rev. no.	rev. date	revision
1		
2		
3		
4		
5-17-07		OWNER REVISION

**MODERNIZATION**  
FOR  
**COLONEL HOWARD NICHOLS SCHOOL**  
3401 RENEGADE AVE.  
BAKERSFIELD, CA. 93306  
BAKERSFIELD CITY SCHOOL DISTRICT

**BUILDING 100 FLOOR PLAN**

**BUILDING 100 FLOOR PLAN**

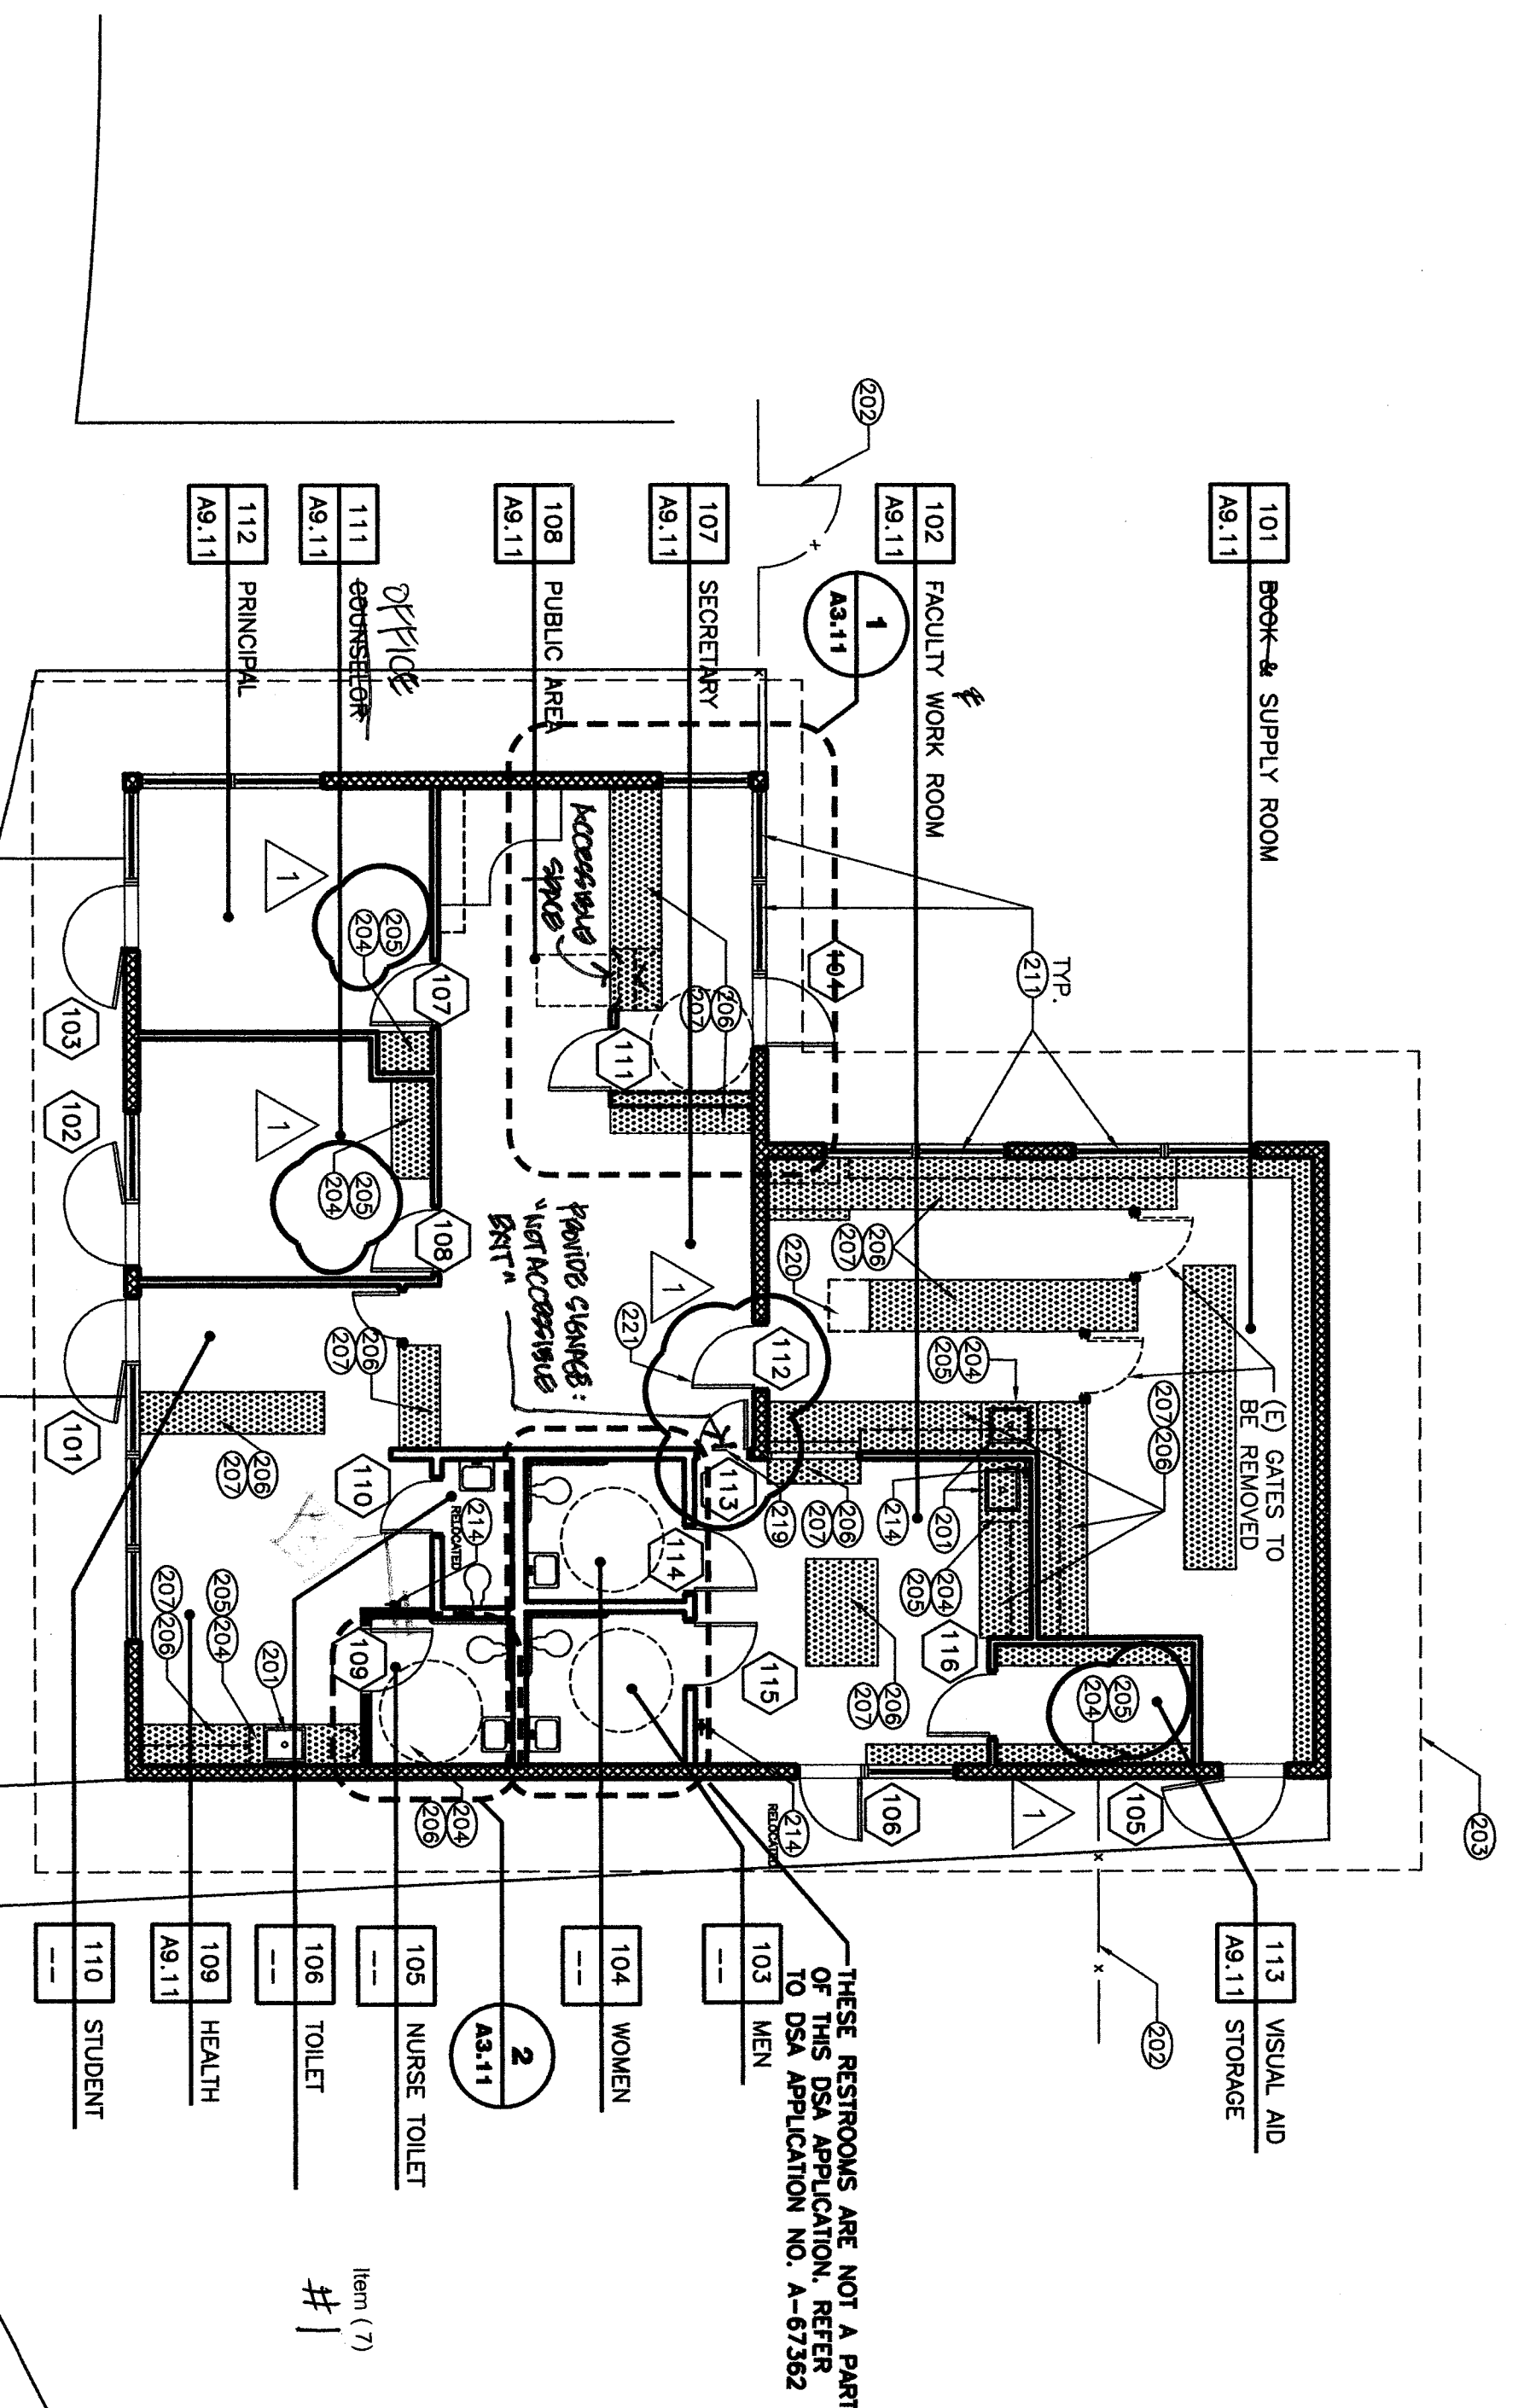
Item (4)  
#4  
Refer to Architectural Drawings, Sheet A2.11 - Building 100 Floor Plan;  
DELETED equipment of existing front counters, including Door 111 (Kerolan, 208 & 207) and Detail 1/A3.1 in Public Area (108). This casework has been replaced by the District with modular furniture.

Item (7)  
#1  
Refer to Architectural Drawings, Sheets A2.11 and A3.11 - Building 100 Floor Plan;  
CLARIFY wall type for Toilet (105) as 'Wall Type 99' (similar with gypsum board one side and the other @ 5'3").
